CALL NO. 100
CONTRACT ID NO. 251309
ADDENDUM # 2

Subject: Boone County, NHPP 0713(069)
Letting April 24, 2025

- (1) Revised - Summary Sheet - Page 29 of 255
- (2) Revised - Special Notes - Page 36-41A of 255
- (3) Revised - Detail Sheets - Page 70 & 71 of 255
- (4) Added - Aux Lane Detail Sheet - Page 70A of 255
- (5) Added - Detail Sheet - Page 103A of 255
- (6) Added - Special Note - Page 103B-103F of 255
- (7) Revised - Proposal Bid Items - Page 253-255 of 255

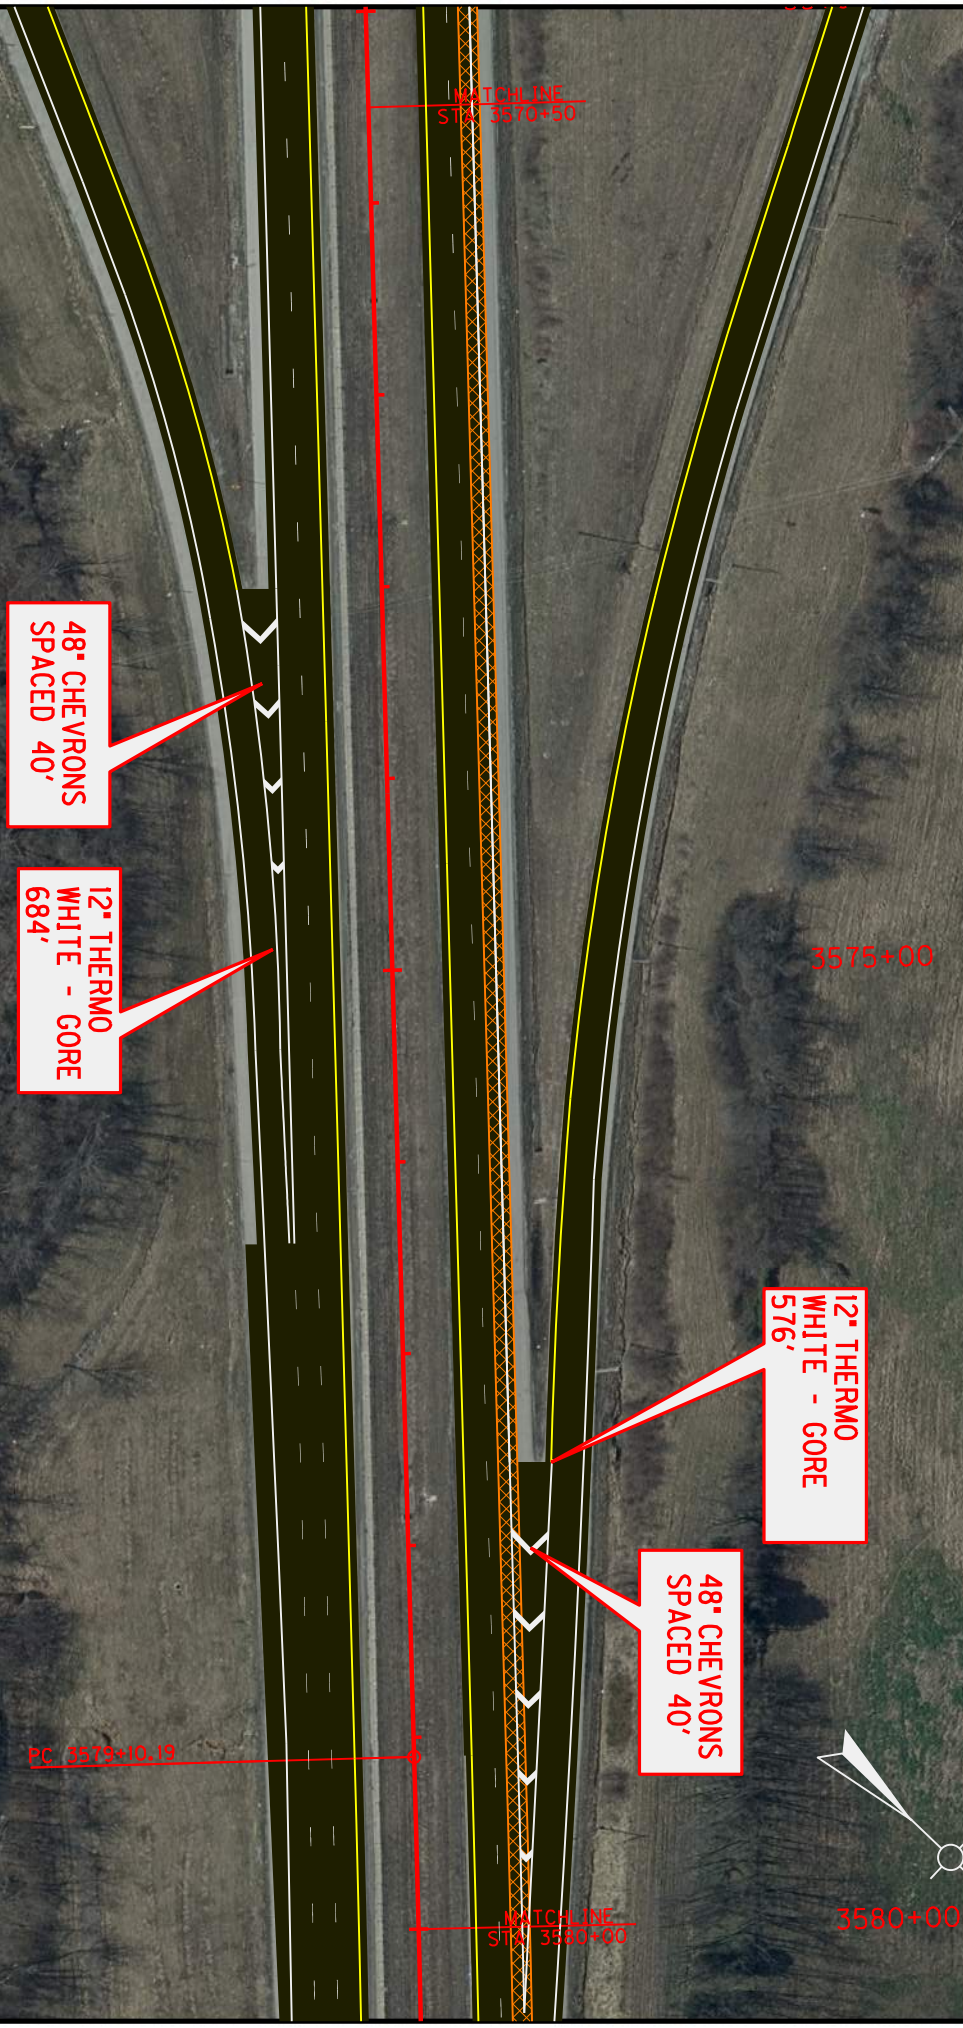
33. Bull Nose end treatments shall be constructed as per the sepia drawings found within this document. Contrary to the sepia, post information will be given only for post 13 at each of the locations. The Contractor shall layout the end treatments per the spacing indicated within the sepia based off the location for post 13. Once laid out, the Contractor shall "dry fit" the end treatment in place prior to driving posts. During the "dry fit" posts can be adjusted to meet the layout. The KYTC will review the layout prior to the Contractor driving posts.

For the two symmetrical layouts at KY 14 and KY 1292 post 13A has the following values:

X=6'-3" from the face of the concrete

Y=7'-4 5/8" from the centerline of the concrete pier

For the asymmetrical layout at the I-71NB over I-75 bridge, post 13 has the following values:

X=136'-9" from the armored edge of the northbound bridge

Y=10'-0" from the northbound yellow line

The intent is for the contractor to layout the bull nose end treatments in the field based off the locations specified above in conjunction with the sepias. As stated in the sepia, post 5 should be a minimum of 50' from the object we are protecting against (in this case bridge piers and bridge ends). The specified maximum tapers listed shall be adhered to. If during layout, these tapers cannot be obtained, increasing the x value listed above of post 13 from the object in question is acceptable. The Contractor will ensure that for the asymmetrical end treatment, offset from the roadway is 10' min from the yellow line at post 13A as shown.

BOONE COUNTY
L71
PLAN SHEET 15 OF 48

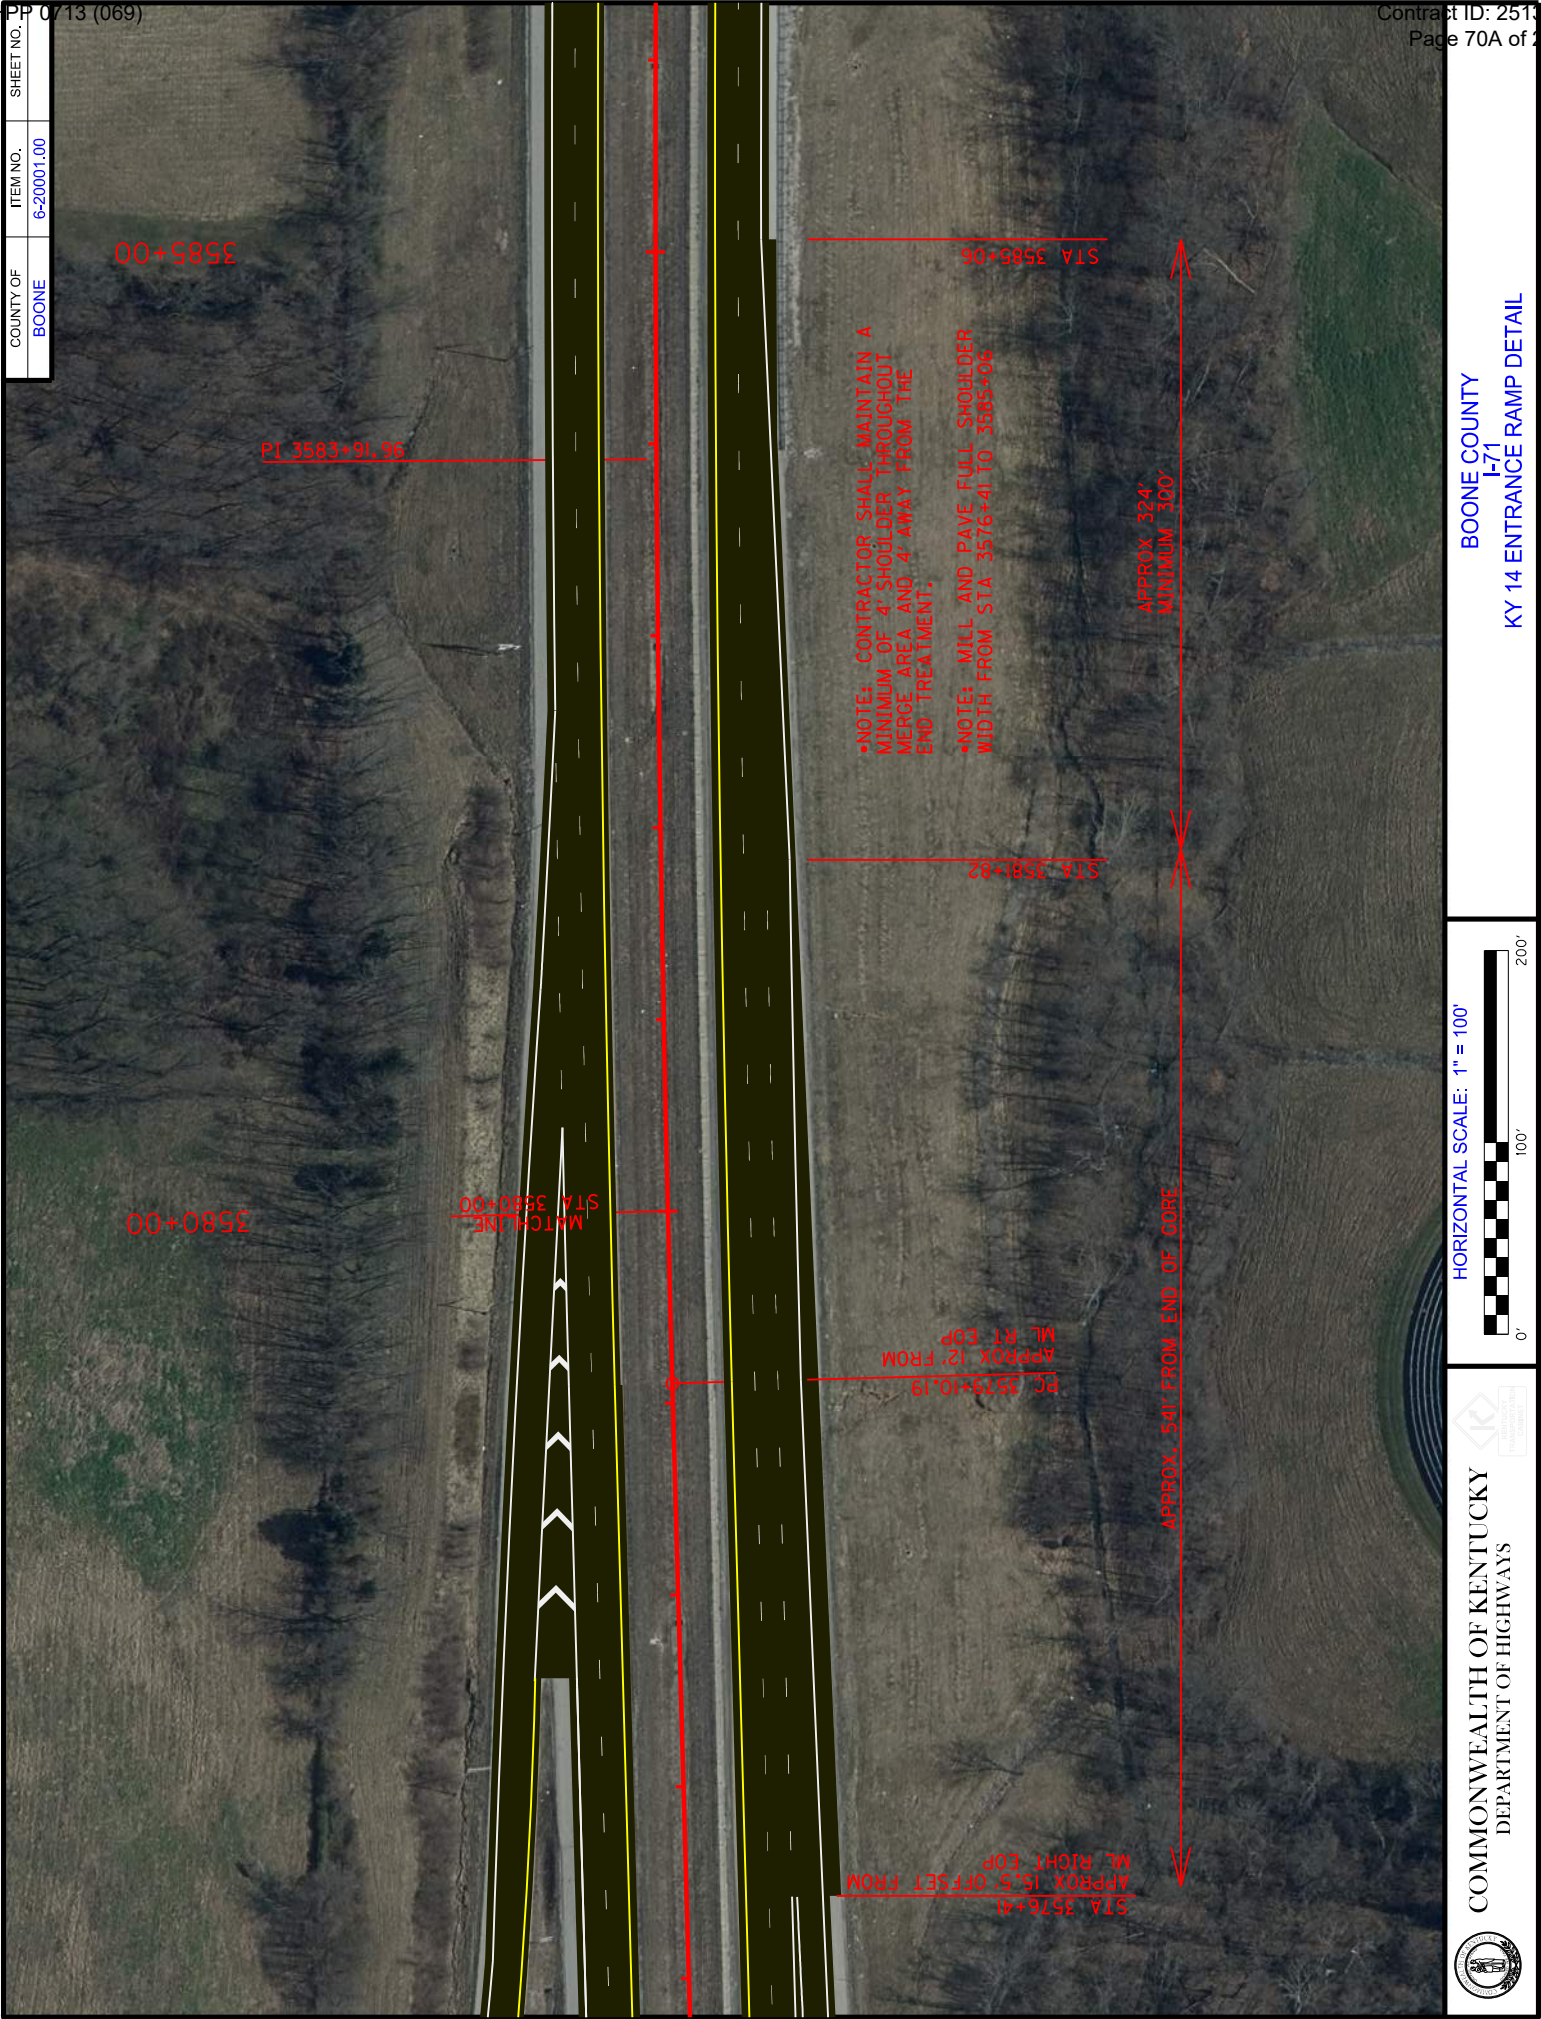
36. The northbound entrance ramp from KY 14 shall be restriped to extend the parallel taper more in-line with current standards. Existing shoulder thickness does not need to be adjusted. The acceleration length shall be lengthened as shown in the proposal by reducing the shoulder width in the merge area. The Contractor shall maintain a 4' outside shoulder in this area and a minimum of 4' away from the end treatment as noted. In the area shown on the plans, mill the entire shoulder width and resurface.

BOONE COUNTY
L-71
PLAN SHEET 16 OF 48

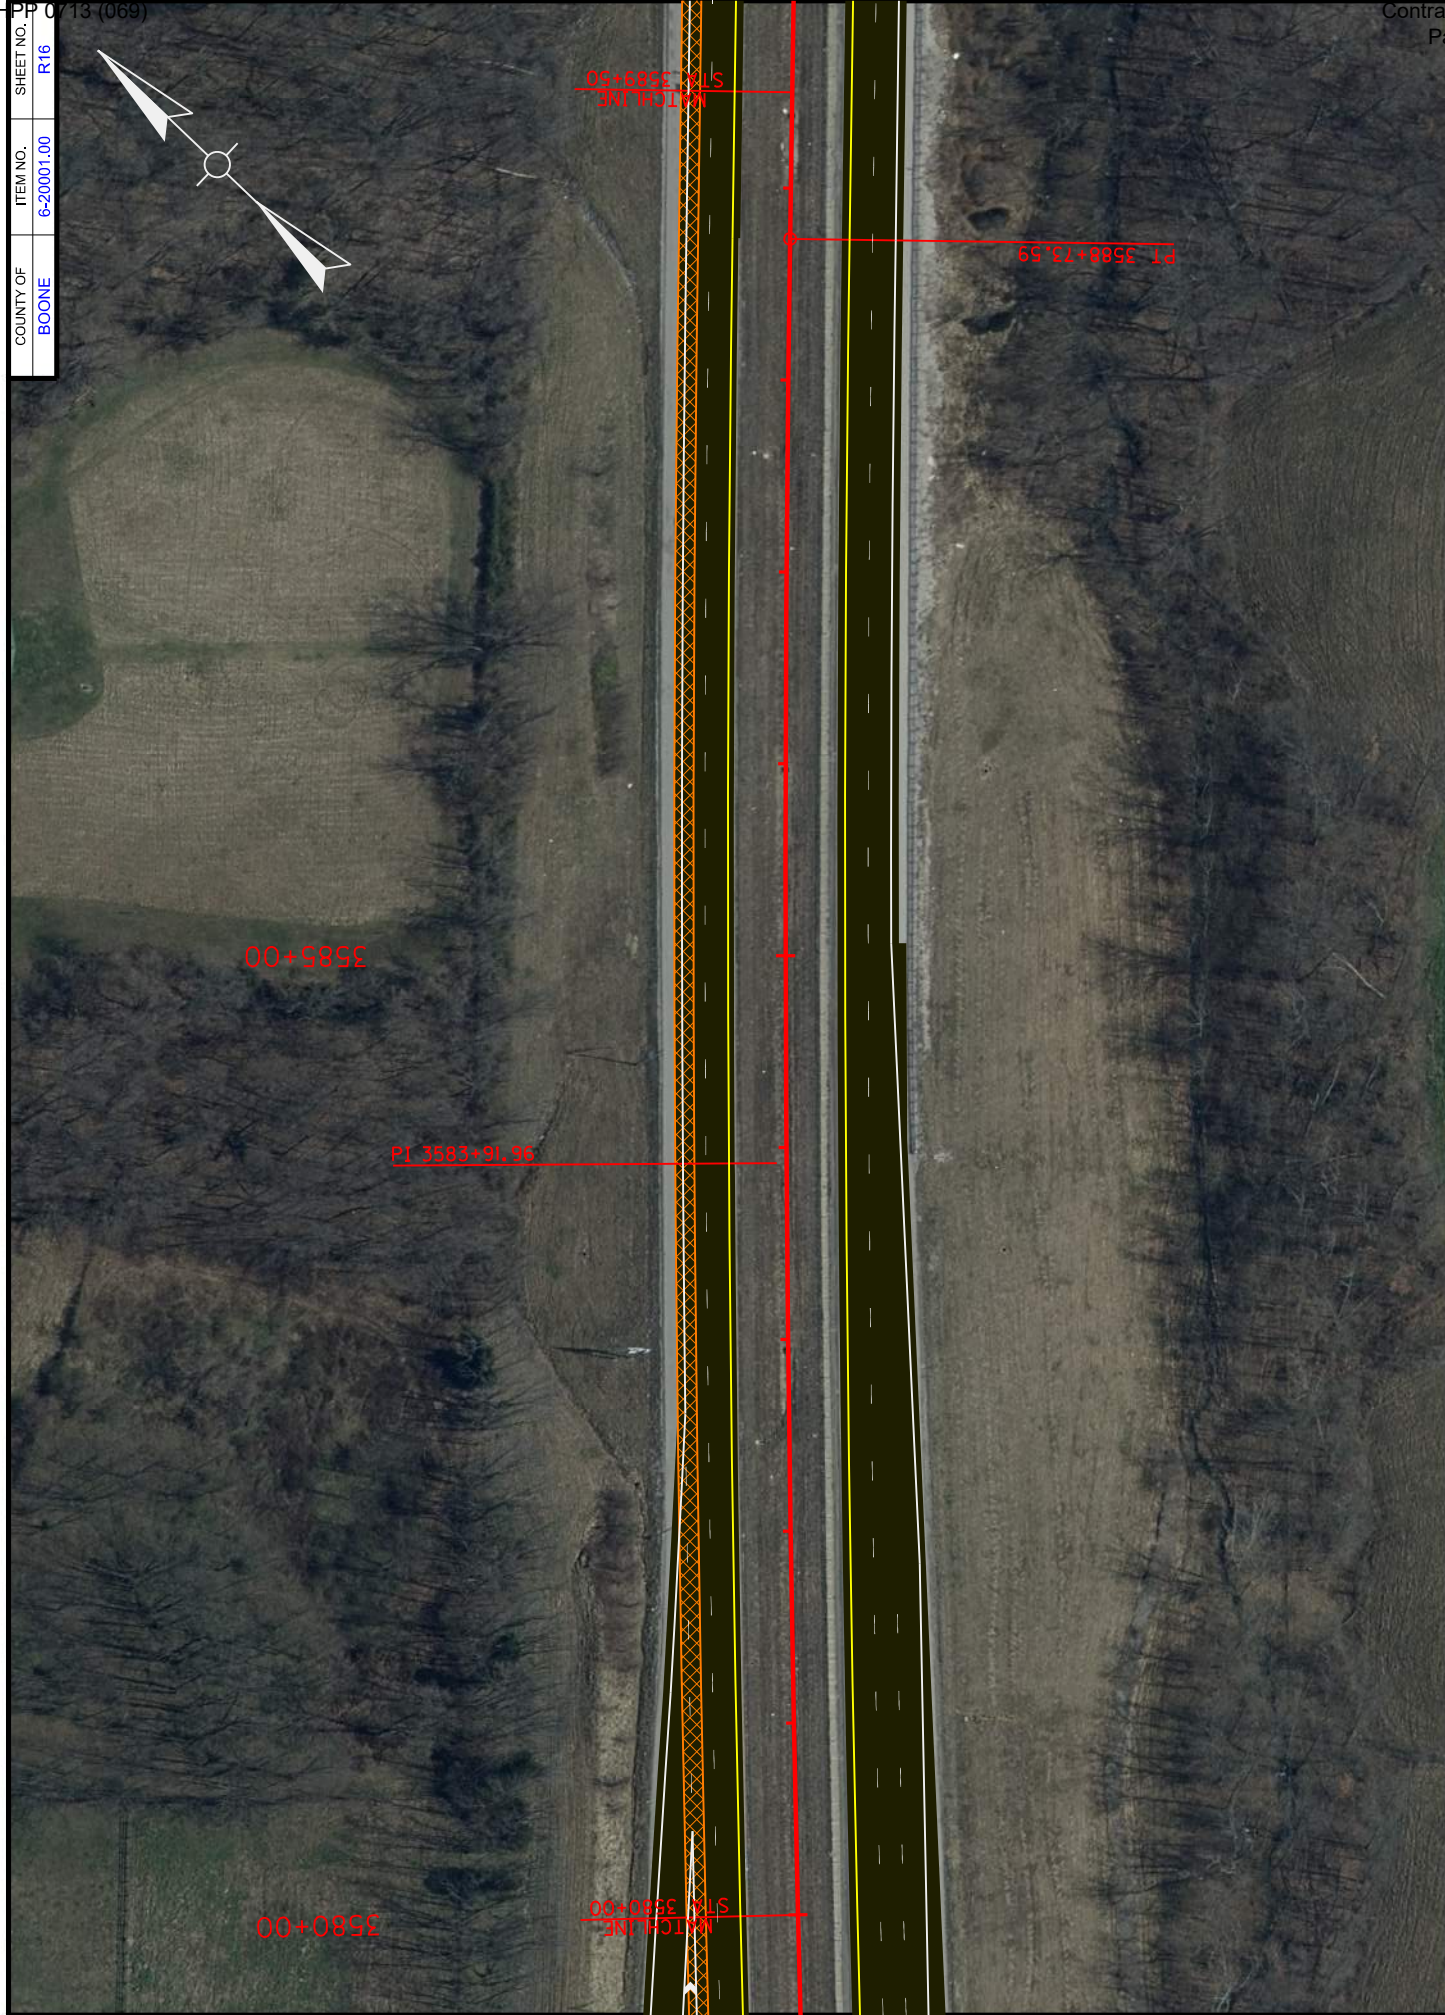
37. On the ramp from I-71 NB to I-75 NB there is an approximately 50' area where the cross slope and the vertical profile are minimal. In an effort to provide drainage movement in the area, the contractor shall wedge as shown in the plans to install a vertical profile of 1% minimal for the area in question. A detail sheet and special note are provided in the proposal as to existing and proposed elevations. Due to the increase in pavement thickness, traffic will be reduced to 1 lane and the contractor will work continuously to raise both lanes as shown, moving traffic around the work zone. No temporary striping or barrier wall is required, but traffic shall be guided using barrels. An 11' driving lane and 2' shoulders shall be required. If guardrail must also be adjusted in this area it shall be paid for in accordance with the standard specifications. A quantity for Leveling & Wedging 76-22 and DGA are set up for this work. Additional guardrail adjustment may be required in this area as directed by KYTC.
